## TACOMA PUBLIC UTILITIES, UTILITY TECHNOLOGY SERVICES

**ADDENDUM NO. 1**

**REVISIONS TO:  
Request for Proposals Specification No. PI23-0258F  
DISTRIBUTED ANTENNA SYSTEM PROJECT**

**4th floor comm room photos:**

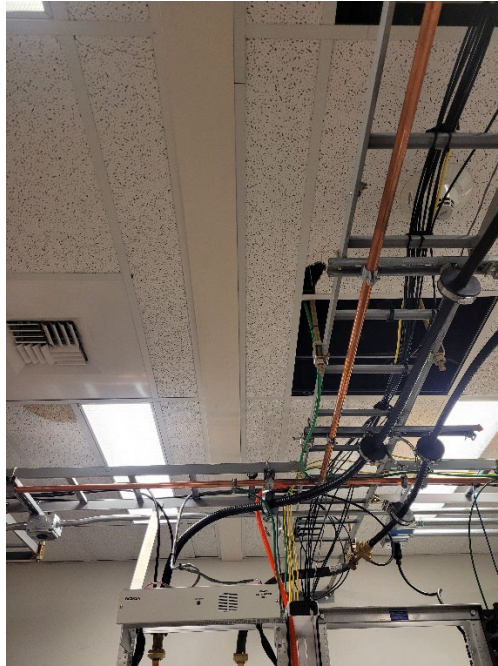
**Question 37: Can we get some photos of the 4th floor comm room?**

Answer 37: See photos at end of Addendum 1.

**Proposed location for wall-mounted equipment**

**Proposed equipment rack location**
